# Road Safety Audit Report

**Incorporating  
Stage 1 Completion of Preliminary Design; and  
Design Organisation Response to items raised.**

## **Proposed highway works and intensification of an existing access to a proposed Clay Pit off Loxwood Road**

<b>Job no</b>	RSA-20-158	<b>Issue no</b>	3	<b>Date</b>	March 2021
<b>Prepared by</b>	JJF	<b>Verified by</b>	FB	<b>Approved by</b>	JJF
<b>Filename and Path</b>	Fenley/Road Safety Audits/RSA-20/RSA-20-158-3

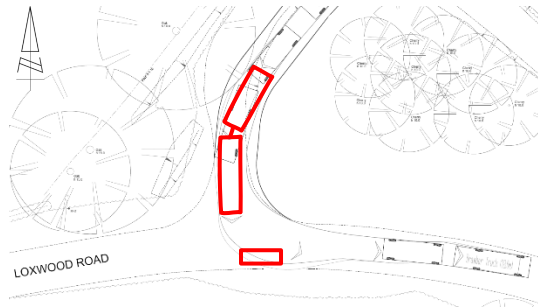
<b>A.1</b>	<b>LOCAL ALIGNMENT</b>
	<i>No Road Safety Concerns regarding LOCAL ALIGNMENT have been raised at this stage</i>
<b>A.2</b>	<b>GENERAL</b>
<b>A.2.1</b>	<b>PROBLEM</b>
<b>Location:</b>	Lay-by / proposed access road
<b>Summary:</b>	Width of carriageway is insufficient for two vehicles to pass one another
<b>Acc Type:</b>	Sideswipes as well as head-on and rear end collisions
<p>Loxwood Road is single carriageway rural road that is derestricted (subject to a 60mph speed limit), accommodates a number of bends where forward visibility is restricted and forms a link between the A281 at Rudgewick to the east and Loxwood to the west. An off-line lay-by is present off the northern side of Loxwood Road that forms a loop and allows for parking as well as access to a single dwelling and a gated access to Tilhill Forestry. Although the Audit Team are unsure if it is generally the case, observations made during the site visit associated with this Stage 1 Road Safety Audit show that vehicles access the lay-by from the west and exit via the access to the east. The proposals that are subject to this Stage 1 Road Safety Audit include the minor widening of the access to the west and provision of a 5.5 metre wide carriageway to allow access to the existing gated entrance to the application site. The existing lay-by to the northwest of the proposed carriageway, is to be retained for parking. No works are proposed to the section of the lay-by to the east of the existing gated entrance. It is understood that the proposed works are to facilitate the movement of HGV's picking up and dropping off materials within the application site with up to 21 HGV's expected to be observed per day generating 42 HGV movements. The documents provided with the Audit Brief, identify that the proposed minerals extraction site is to operate between 8am and 6pm and as such, an average of 4.2 HGV movements will be observed per hour. The scheme drawings provided with the Audit Brief, illustrate the swept path of the expected vehicles; an 18 metre drawbar truck and a 10.2 metre large tipper and identify shows that the access road is not adequate for two vehicles to pass one-another. Should a vehicle arrive whilst another vehicle is leaving, one would be required to encroach the area either side of the proposed access road which could result in loss of control or sideswipe type collisions with parked vehicles.</p>

<b>RECOMMENDATION:</b>	
It is recommended that the width of the access road is increased to allow HGV's to pass one another.

<p><b>Location Plan:</b></p>	
<p><b>DESIGN ORGANISATION RESPONSE</b> provided by Nick Culhane on the 18<sup>th</sup> March 2021 following formal issue of this Stage 1 Road Safety Audit on the 18<sup>th</sup> February 2021</p>	
<p>Accepted - The access with Loxwood Road is existing and two vehicles are not able to pass one another at this junction at present. However, the bell mouth junction is now shown to be widened to accommodate the turning requirements of a large tipper lorry without the need to encroach onto the oncoming carriageway. The scheme will now only utilise type 1, 2 and 3 tipper lorries, 3 being the largest that is illustrated on the revised swept path analysis drawings. Deliveries will be managed so that vehicles will be staggered, but should a lorry arrive when another is seeking to exit the site, the exiting vehicle will be able to do so without impediment of the waiting vehicle.</p>

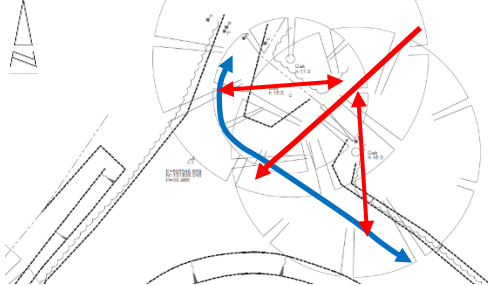
**Location:** Loxwood Road west

**Summary:** Achievable visibility is limited to below the speed limit of the road

**Acc Type:** Rear end impact collisions

Loxwood Road is single carriageway rural road that is derestricted (subject to a 60mph speed limit), accommodates a number of bends where forward visibility is restricted and forms a link between the A281 at Rudgewick to the east and Loxwood to the west. An off-line lay-by is present off the northern side of Loxwood Road that forms a loop and allows for parking as well as access to a single dwelling and a gated access to Tilhill Forestry. Although the Audit Team are unsure if it is generally the case, observations made during the site visit associated with this Stage 1 Road Safety Audit show that vehicles access the lay-by from the west and exit via the access to the east. The proposals that are subject to this Stage 1 Road Safety Audit include the minor widening of the access to the west and provision of a 5.5 metre wide carriageway to allow access to the existing gated entrance to the application site. The existing lay-by to the northwest of the proposed carriageway, is to be retained for parking. No works are proposed to the section of the lay-by to the east of the existing gated entrance. It is understood that the proposed works are to facilitate the movement of HGV's picking up and dropping off materials within the application site with up to 21 HGV's expected to be observed per day generating 42 HGV movements. The documents provided with the Audit Brief, identify that the proposed minerals extraction site is to operate between 8am and 6pm. The scheme drawings provided with the Audit Brief, illustrate that a visibility splay of 2.4x148.1 metres is achievable to the right (west) of the proposed access and that 2.4x104.4 metres is achievable to the northern channel line, to the left (east) with a measurement of 90 metres achievable to the nearside channel line of the approaching lane. This distance accords with the Stopping Sight Distance associated with the observed 85<sup>th</sup> percentile speed of vehicles approaching the access, is as per the existing and hasn't resulted in any recorded personal injury collisions, however, Loxwood Road is derestricted and could therefore observe greater speeds. The driver of vehicle travelling in excess of the observed 85<sup>th</sup> percentile speed will not be aware of the access to the proposed minerals extraction site and the potential for slow moving HGVs blocking the carriageway ahead which could give rise to heavy braking and loss of control type incidents.

<b>RECOMMENDATION:</b>	
It is recommended that an appropriate warning signs is provided.	
<b>Location Plan:</b>	
<p>The diagram shows a plan view of Loxwood Road. A junction is highlighted with a red circle and red arrows pointing towards it from the east. Three visibility splays are shown with dashed lines and labels: 'VISIBILITY SPLAY 2.4x148.1 METRES', 'VISIBILITY SPLAY 2.4x104.4 METRES', and 'VISIBILITY SPLAY 2.4x104.4 METRES'. A north arrow is located in the top left corner.</p>	
<b>DESIGN ORGANISATION RESPONSE</b> provided by Nick Culhane on the 18 <sup>th</sup> March 2021 following formal issue of this Stage 1 Road Safety Audit on the 18 <sup>th</sup> February 2021	
Accepted - The scheme will include appropriate warning signs to be agreed by the highway authority to forewarn drivers approaching from the east, that there is a junction and / or lorries are turning.	
<b>A.4</b>	<b>WALKING CYCLING AND HORSE RIDING</b>

### **Item Location Plan**

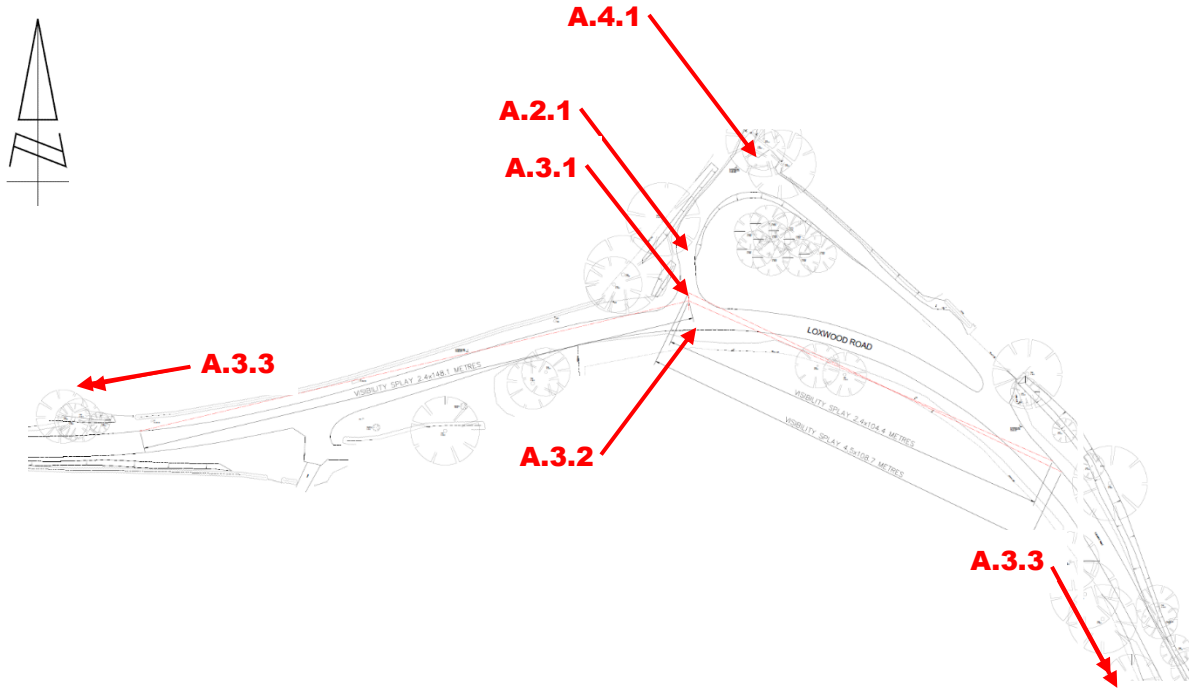
- 2.6 The terms of reference of this Road Safety Audit are as described in GG119. The scheme has been examined and this report compiled, only with regard to the safety implications for road users of the scheme as presented. It has not been examined or verified for compliance with any other standards or criteria. However, in order to clearly explain a safety problem or the recommendation to resolve a problem, the Audit Team may on occasion have referred to a design standard for information only. All comments and recommendations are referenced to the design drawings supplied with the Audit Brief and the location of road safety concerns raised have been illustrated beneath the items along with relevant photographs for clarity, where appropriate, as well as on the Location Plan attached at **Appendix A2**.
